ADDENDUM II

SUBJECT: Food Service and Retail Concessions for San Antonio International Airport, (RFP 26-073, 6100019609), Scheduled to Close: September 23, 2026; Date of Issue: July 10, 2026

THIS NOTICE SHALL SERVE AS ADDENDUM NO. II - TO THE ABOVE REFERENCED REQUEST FOR PROPOSALS

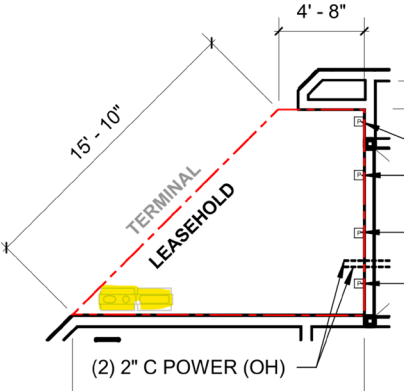
Question 28: Response:	Since no site visit will be held, will the City provide floor plans/CAD files, utility and infrastructure specifications, and design criteria for the Package 3 spaces?

Lease outline drawings (LODs) for each location as well as Tenant Design Guidelines have been issued with this RFP. Updated Tenant Design Guidelines have been issued with this Addendum II. Utility connection points are noted on the LODs.

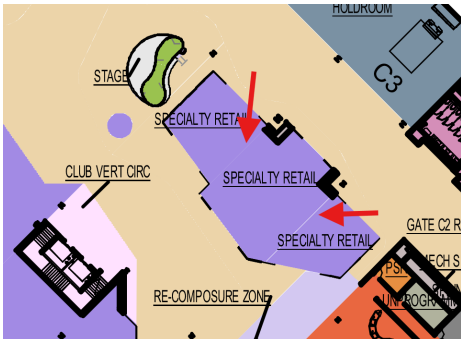
Question 35: Response:	Will the Airport be releasing airline specific growth assumptions or anticipated changes in carrier market share that informed the total enplanement projections through 2040?

The City's expectation is the airport/airline growth is based on the FAA TAF (Terminal Area Forecast).
Question 36: Response:	The RFP includes total airport enplanement projections through 2040. Will the City be releasing projected enplanements by terminal (A, B, and C) to help proposers align concepts, staffing, and financial commitments with expected passenger volumes? Please refer to the response to Question No. 20.

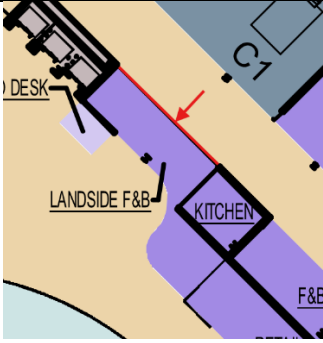
Question 49:	Please provide Exhibit 11: Draft Concession Agreement relating to this RFP.

Response:	C2535, C2536, C2730, C2529, C2606, C2104, C2380, C2390 (Please ignore if spaces below have already asked for square footage confirmation). Please refer to Exhibit 14 - Lease Outline Drawings for the most accurate tenant space areas. The areas shown in the LODs are measured in accordance with Building Owners and Managers Association (BOMA) standards.

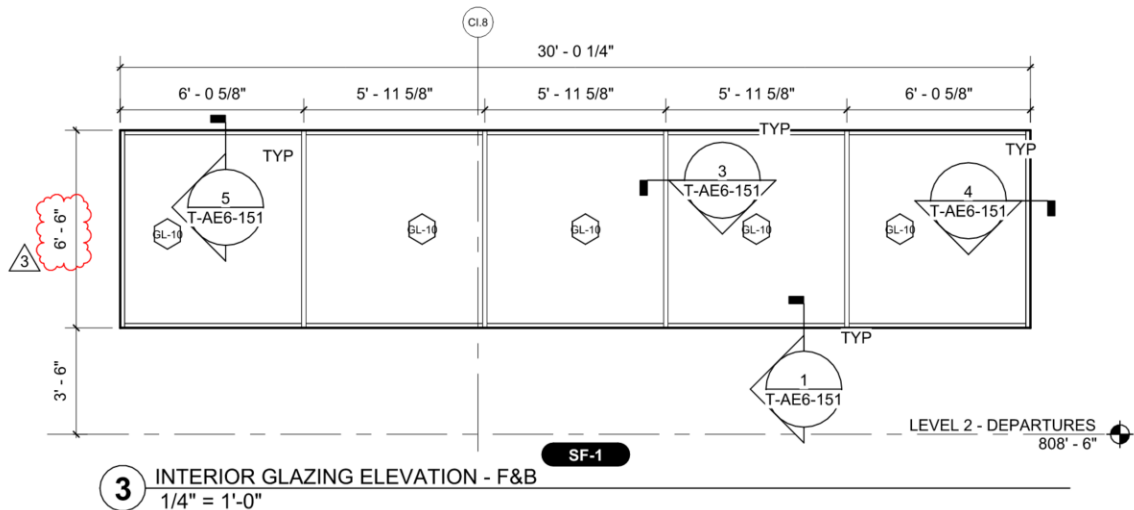
Question 72:	Unit C2406: What are these yellow highlighted elements in the LOD and can they be relocated or removed?

Response:	 These are Airport-provided trash and recycling units for public use. They can be relocated pending proposed Tenant layout.
Question 73: Response:	Unit C2523: Since this space is combined with C2524, can we show both spaces on one plan in our proposal or should they be shown separately? C2524 and C2523 may be shown on one plan if the Respondent is proposing one, combined multi-brand retail store. If the Respondent is proposing two separate concepts, then the two spaces must be shown separately.

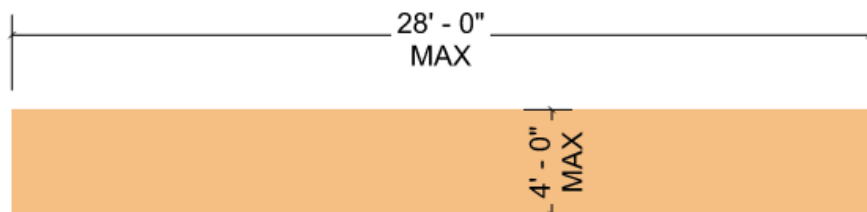
Question 80:	Unit C2534: Are the spaces C2523 and C2524 meant to be open to one another or can there be a dividing wall added?
Response:	The Selected Respondent may build a wall between units C2523 and C2524 if two concepts are proposed.

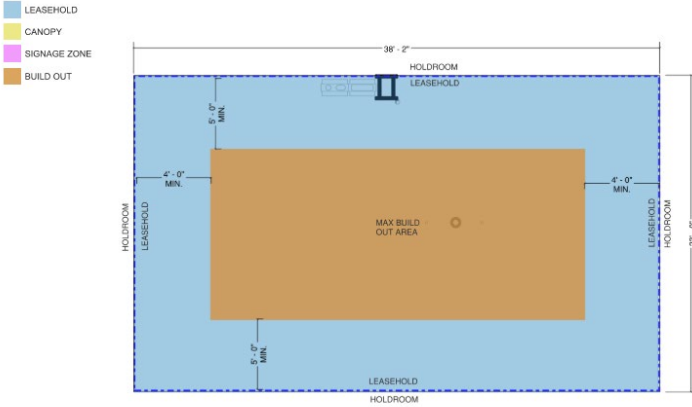
Question 88:	Unit C2536: Can we build out / add electricity or finishes to the base build columns within the LOD?
Response:	Tenants may add electrical service or finishes to the base-building columns located wholly within the LOD as long as they are consistent with Exhibit 10 - SAT Tenant Design Guidelines rev 3.27.26, subject to Airport management review and approval. All work shall be coordinated with the base-building electrical system and shall not compromise the structural integrity of the columns. Please review Section 2.2 of the Tenant Design Guidelines for the design intent against which modifications will be evaluated.
